CITY PLANNING COMMISSION

- APPLICATION:**
- A. Negative Declaration
 - B. Tentative Map
 - C. Special Permit to develop 100 condominiums

PROPOSAL: The applicant is requesting the necessary entitlements to develop 100 airspace condominium units.

APPLC. NO. P85-456 **MEETING DATE** December 5, 1985 **ITEM NO** 24

ELEVATIONS FLOOR PLANS

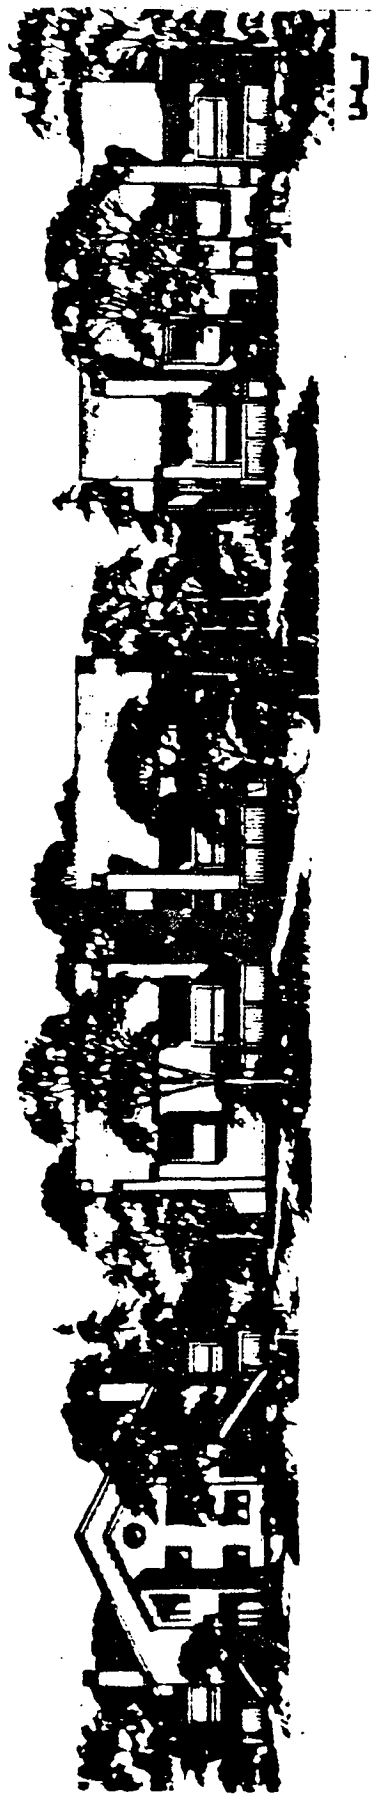
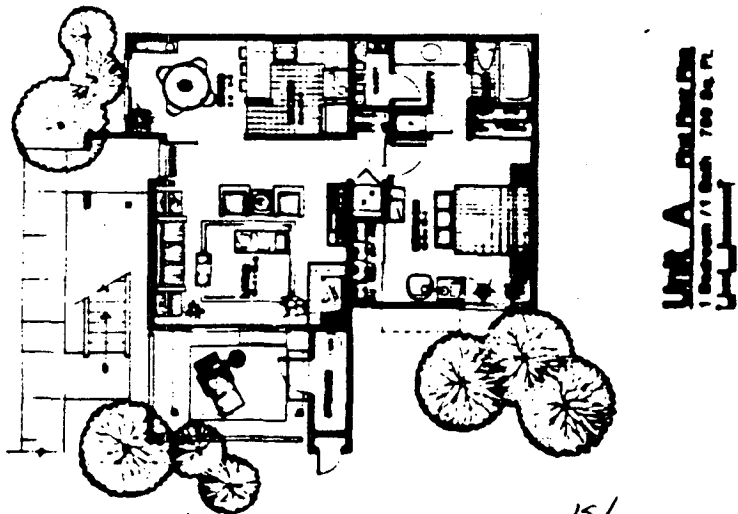
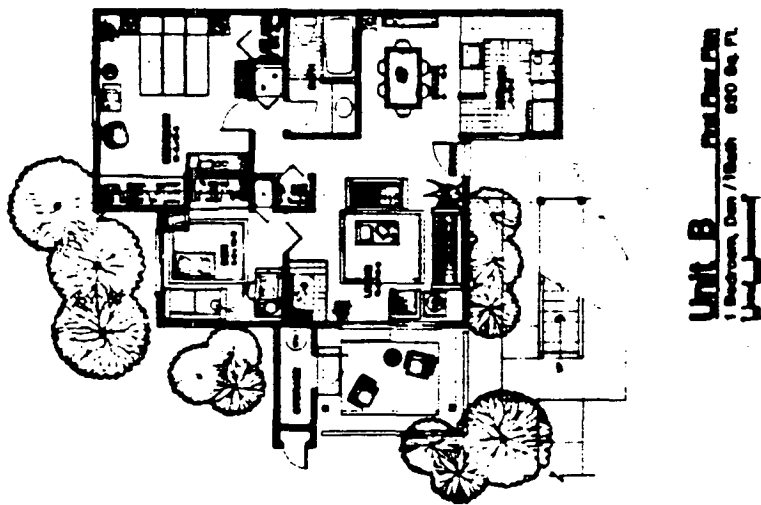
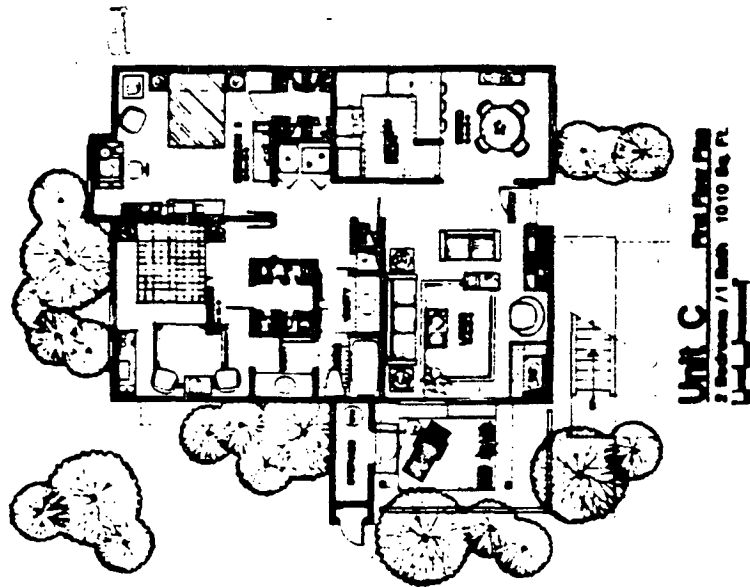
Some of the carport structures would face onto Mack Road. Staff recommends that the carport be designed so as to be compatible in design and materials with the main building. The applicant must submit elevations of the carports for review and approval prior to issuance of building permits. A six foot high solid masonry block wall should be constructed along the south property line as a buffer between the single family residences to the south and the parking area and tennis courts.

6. The applicant shall submit elevations of the carport structure. Carports shall be trimmed with a material which is compatible with the proposed condominium units.

7. The buildings shall include the following items:
 - a. Exterior materials shall include wood and stucco siding.
 - b. Stairs shall have double stringers.

- c. All roofs shall be covered with wood shake, shingle, tile material or heavy butt composition shingle that is approved by the Planning Director.
8. The applicant shall provide a clubhouse facility. Design of facility shall be reviewed and approved by the Planning Director.

TENTATIVE

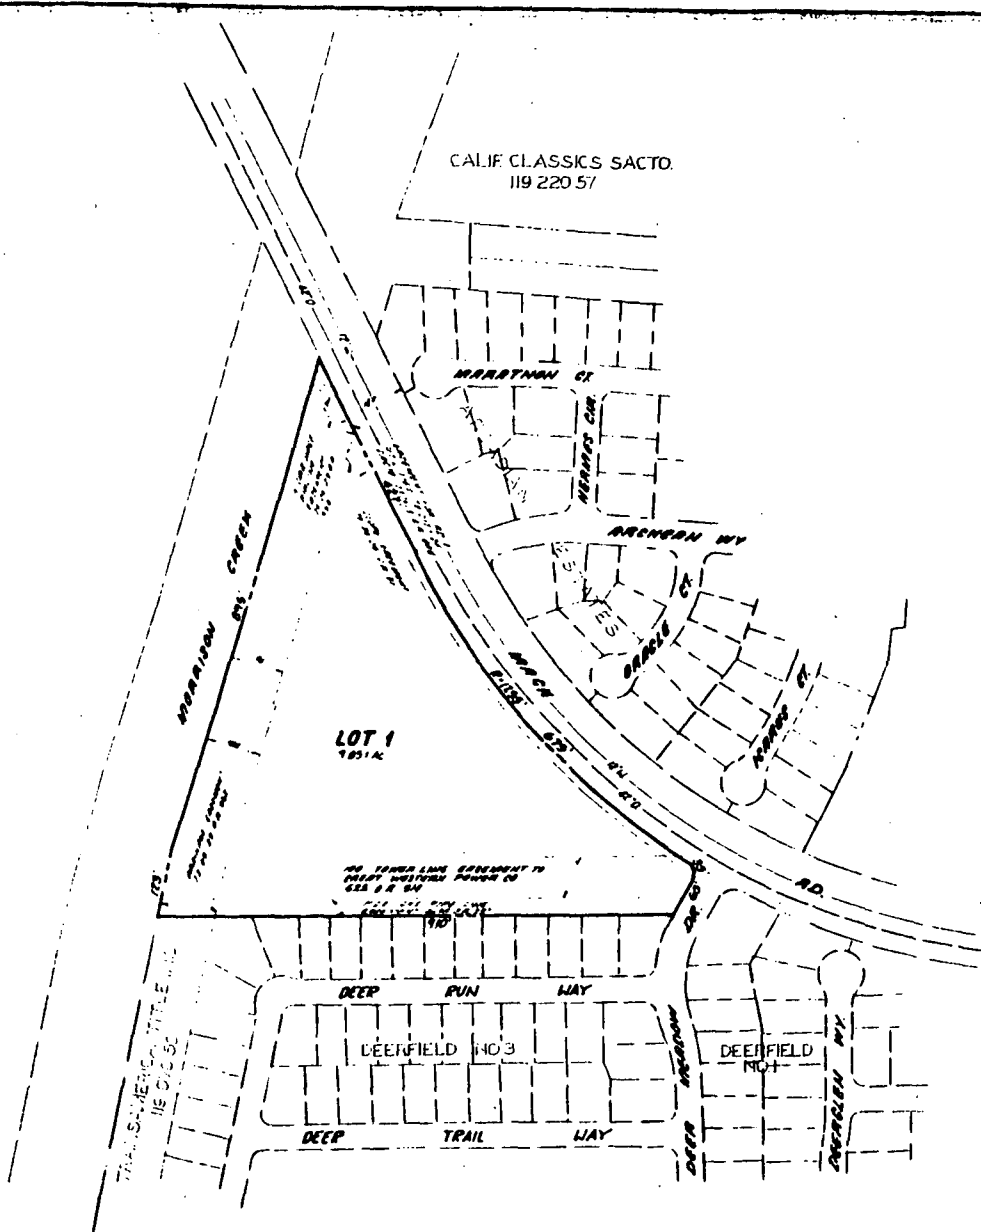
- B. The applicant is proposing a one lot subdivision and 100 airspace condominium units to be developed in two phases. A total of 48 one bedroom and 52 two bedroom units ranging in size from 759-1,010 square feet will be constructed. The proposed site plan shows a cluster of 12 buildings of two stories in height. The site is constrained by a 95 foot drainage easement along the west property line and a 100 foot powerline easement along the south property line.
- C. The exterior building materials for the units will include stucco/wood siding and composition shingle roofs. Staff feels that the building design provides good architectural relief on both the front and end elevations.

- D. No bicycle parking is shown on the site plan. Staff recommends that the applicant provide one bicycle parking facility for every 10 parking spaces as required by the Zoning Ordinance. A revised site plan indicating the bicycle parking areas shall be submitted for review and approval prior to issuance of building permits.

- F. Other site amenities include a tennis court, pool and pond (pool and pond not shown on site plan). A common storage area is also indicated for homeowners' use. The applicant should also provide a clubhouse adjacent to the pool area. The clubhouse design shall be compatible with residential structures and shall be reviewed and approved by staff.

3. The applicant shall provide on-site bicycle parking spaces. A revised site plan indicating the bicycle parking areas shall be submitted for staff review and approval prior to issuance of building permits.

4. Trash enclosures shall be provided in sufficient number and in a convenient location. Additional trash enclosures shall be located on-site and a revised site plan shall indicate the additional enclosures.

5. A six foot high solid decorative masonry block wall shall be constructed along the south property line. Design of the wall shall be reviewed and approved by the Planning Director.
